Serra Mesa Community Plan Amendment Roadway Connection Project: Final Environmental Impact Report

FINAL ENVIRONMENTAL IMPACT REPORT

SUBJECT: SERRA MESA COMMUNITY PLAN AMENDMENT ROADWAY CONNECTION PROJECT

FINAL DOCUMENT August 15, 2017:

Figure 1-1
Project Study Area

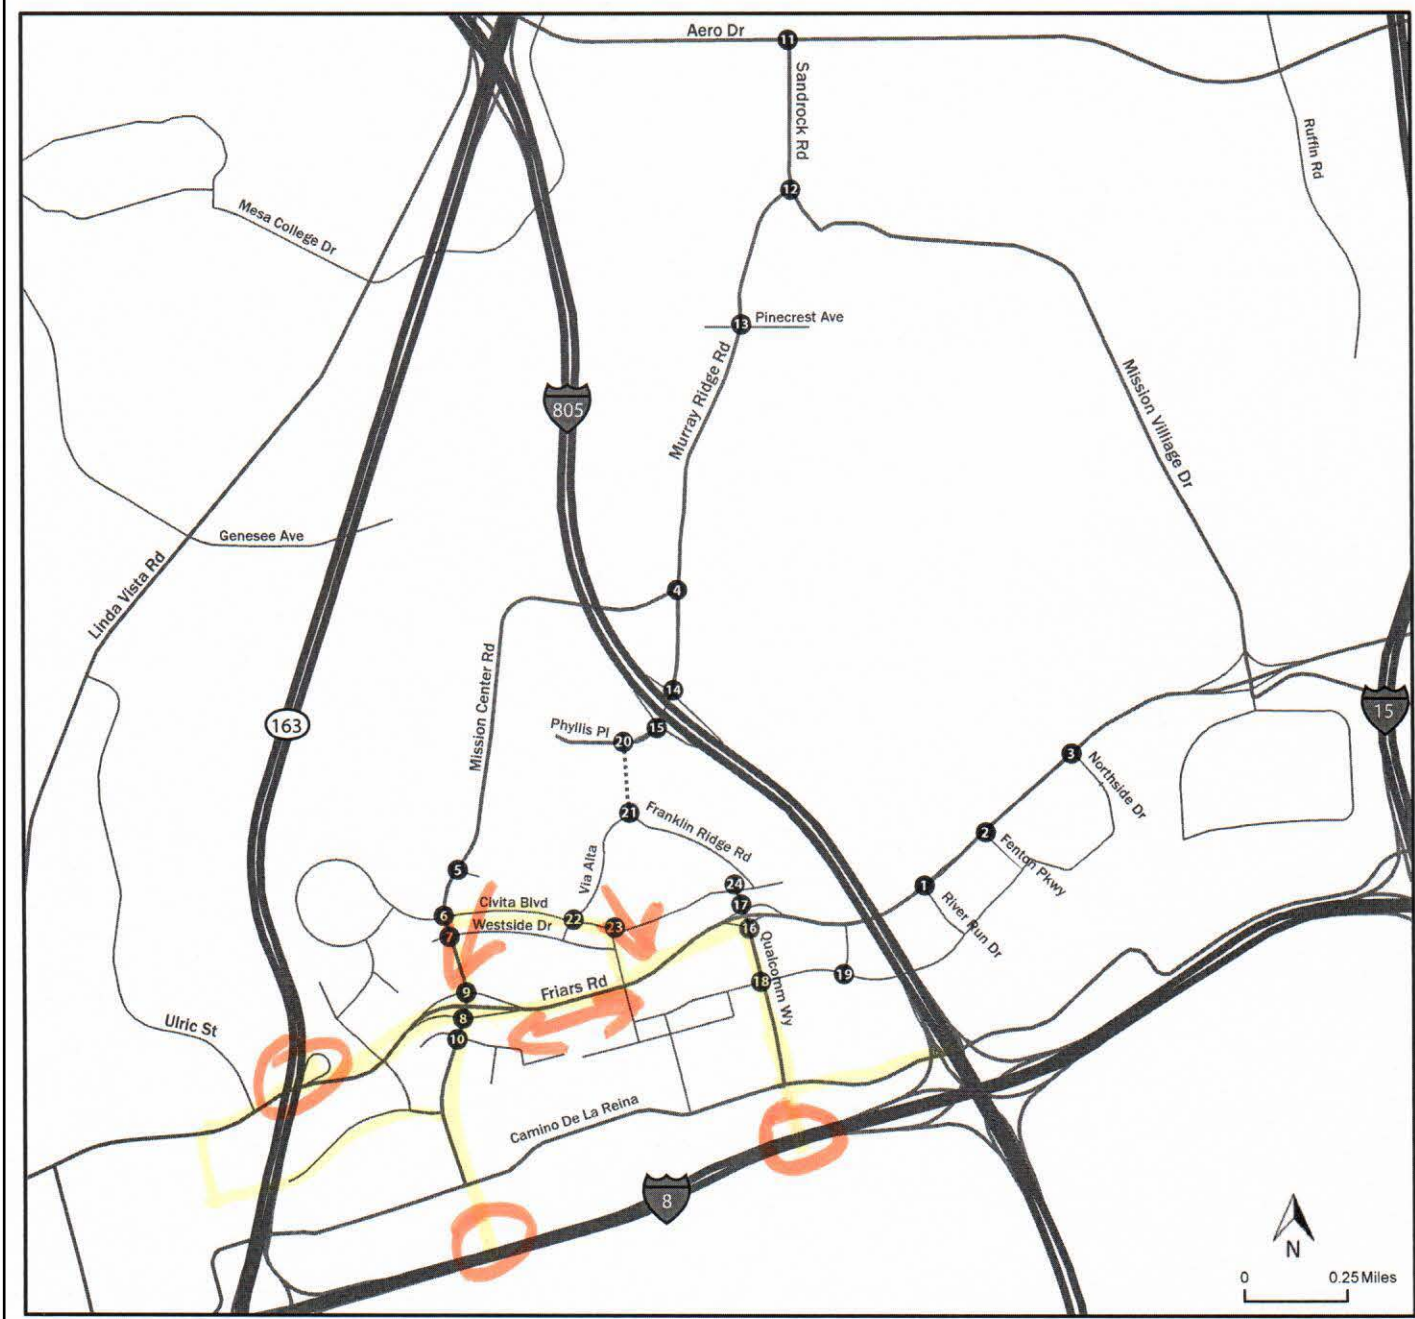
- Figure 5.2-3 is missing the numbering that corresponds with the intersections as defined on 5.2-4.

J-18: This comment states that Figure 5.2-3 is missing the corresponding intersections to the numbering on page 5.2-4.

The map that includes the corresponding intersections to the numbering on page 5.2-4 of the DEIR is included in Figure 1-1, *Project Study Area*, of the KOA TIS, included in Appendix C of the DEIR. The FEIR has been corrected. This revision does not result in an increase of the severity of the impacts or represent significant new information as this information was available in the traffic study appended to the EIR and circulated for public review.

Figure 5.1-1
General Plan Land Use Designation

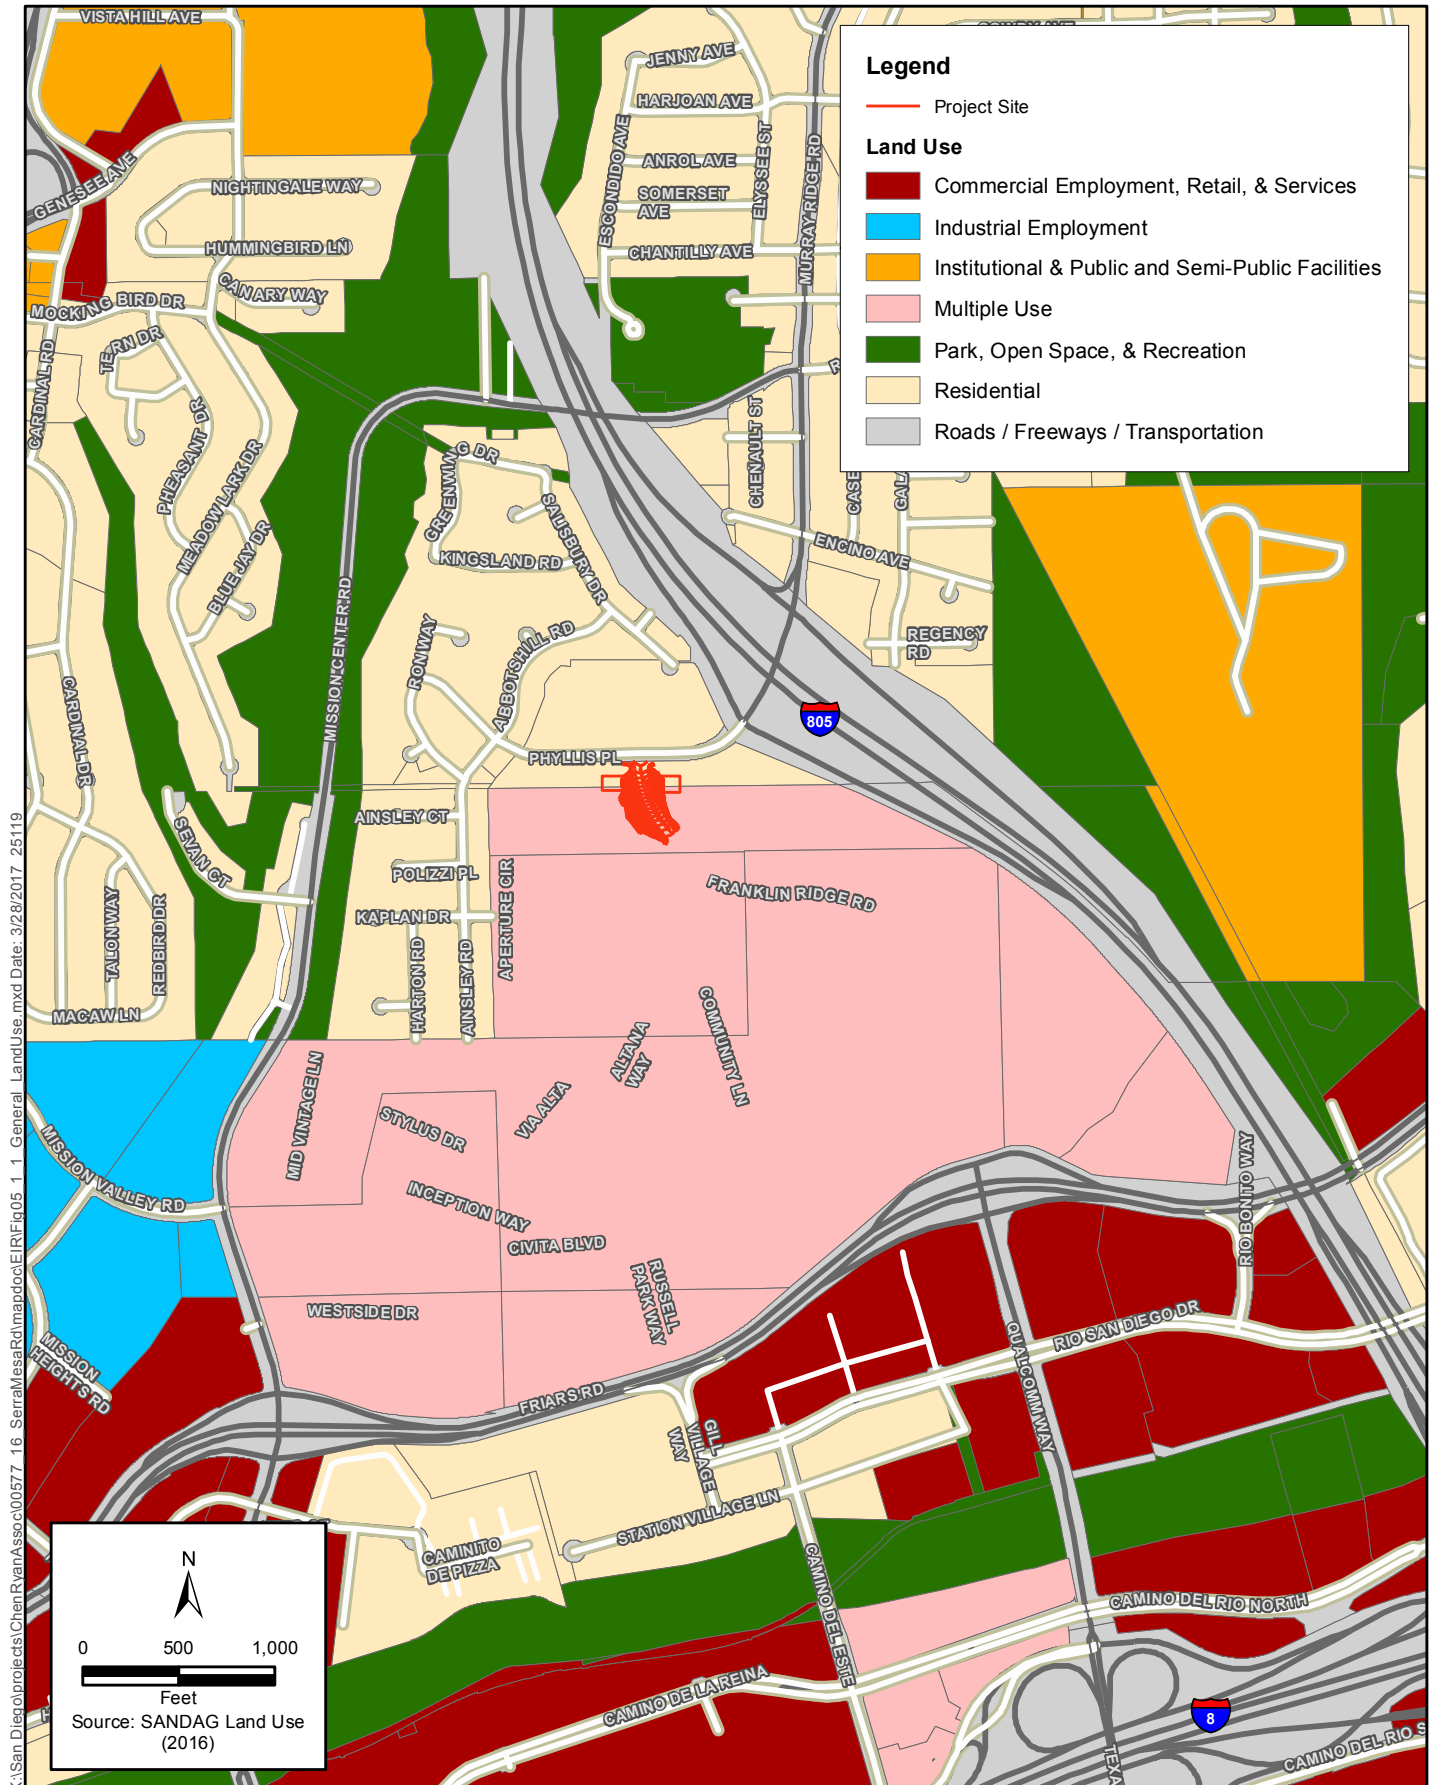
However the RDEIR provides land use according to the General Plan Land Use Designation in Figure 5.1-1 which describes the project area as a combination of **Residential** and **Multiple Use**.

The Serra Mesa Community Plan designates the project site within the Serra Mesa Community Planning area as Residential, and the adopted land use is correctly reflected as Residential in Figure 5.1-1 of the DEIR.

Figure 5.2-2
Existing Circulation Network

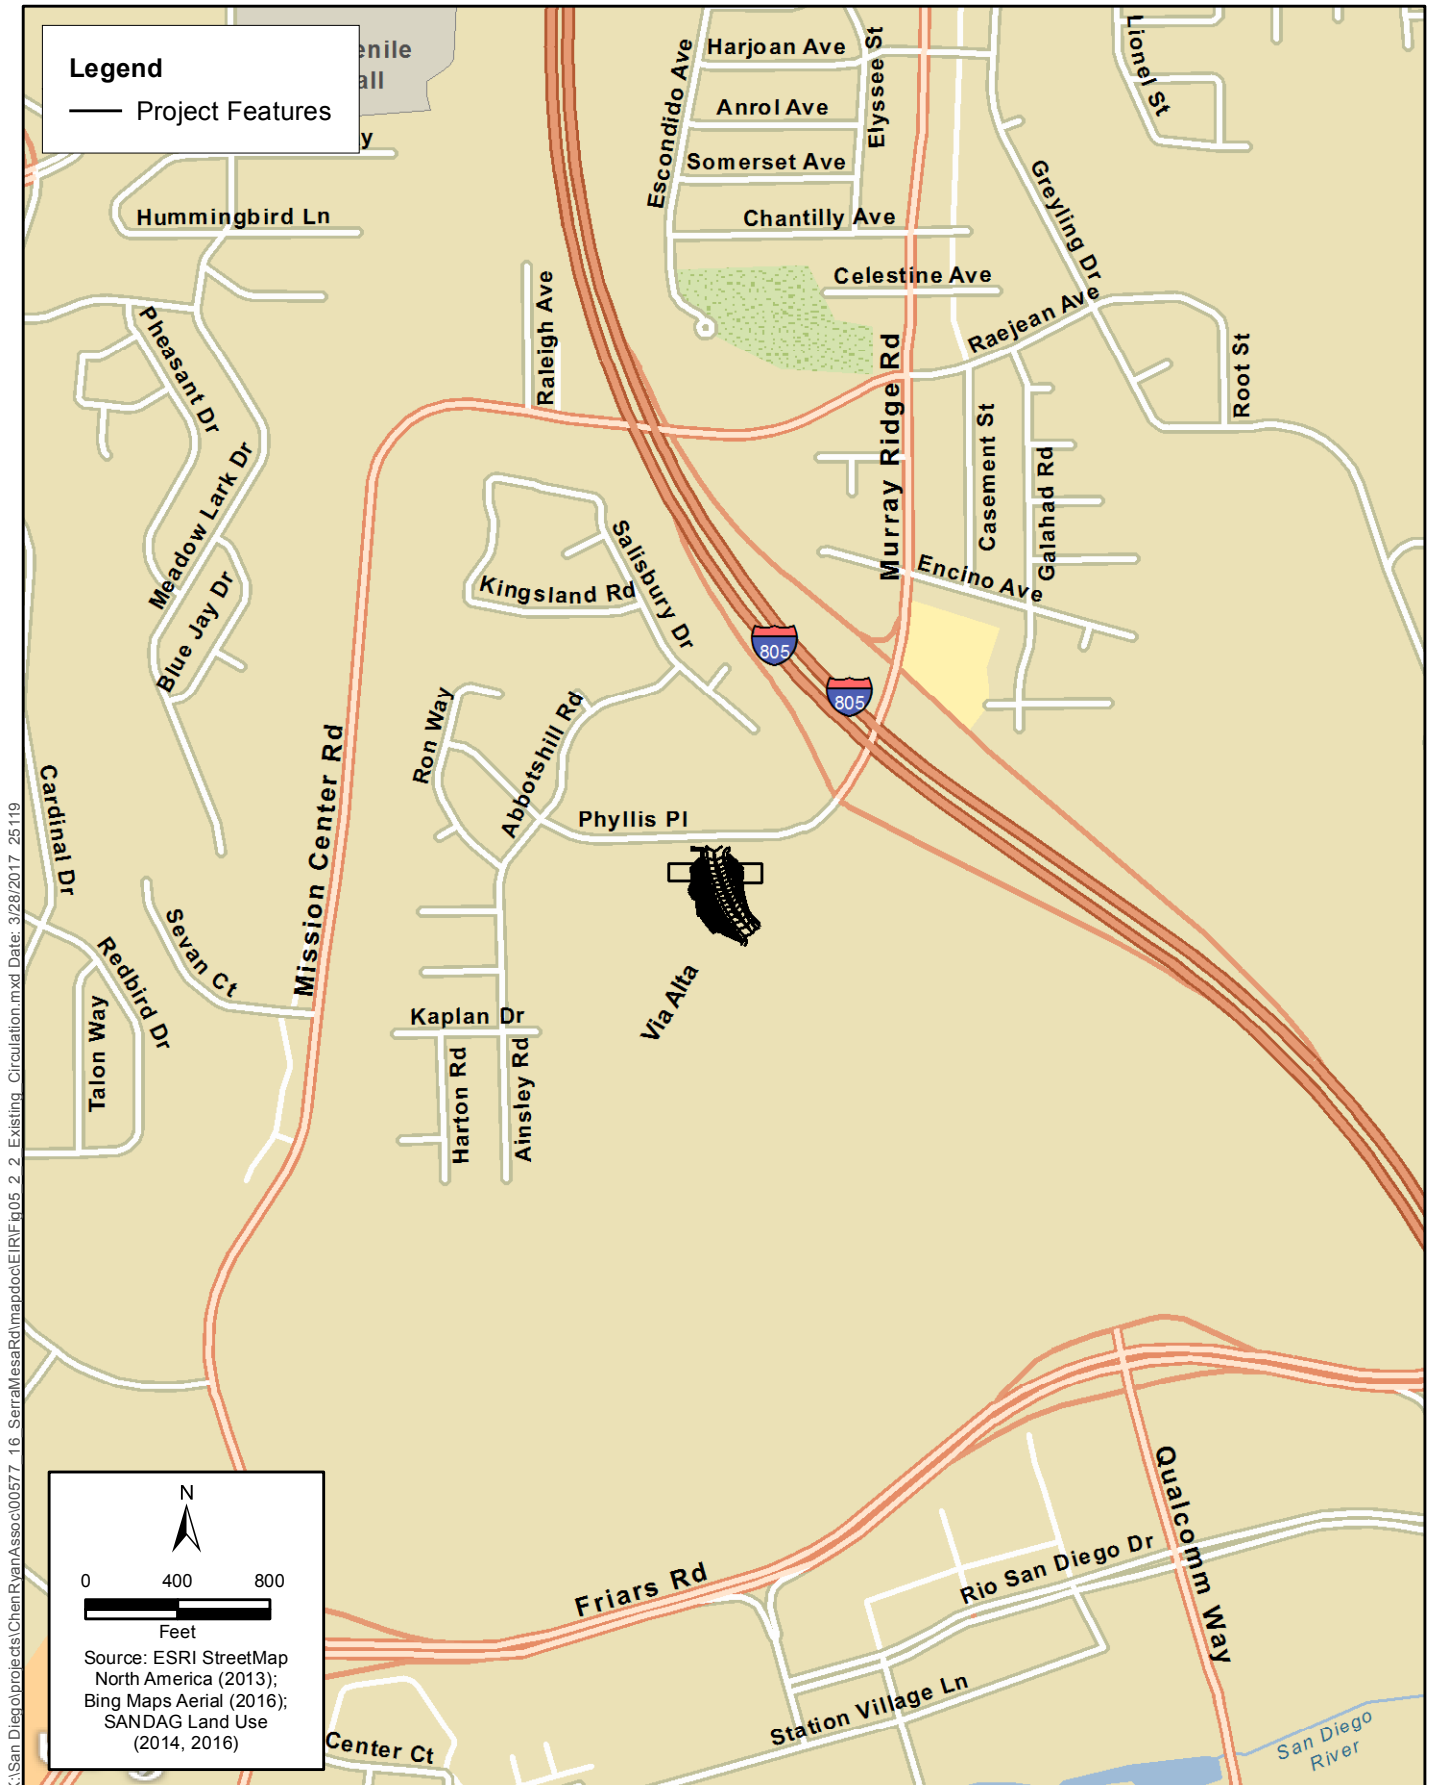
- Figure 5.2-2 does not include Quarry Falls roads that were open and operational as of April 2015.

J-19: This comment states the Figure 5.2-2 does not include roadways within Quarry Falls that were open and operational as of April 2015.

Please refer to Figure 2-4, Existing Roadways, within the DEIR. This figure showed the existing roadways that were operational as of April 2015. Figure 5.2-2 shows the existing roadway system as of 2012, when traffic counts were conducted for the proposed project. No revisions to the FEIR are warranted as a result of this comment.
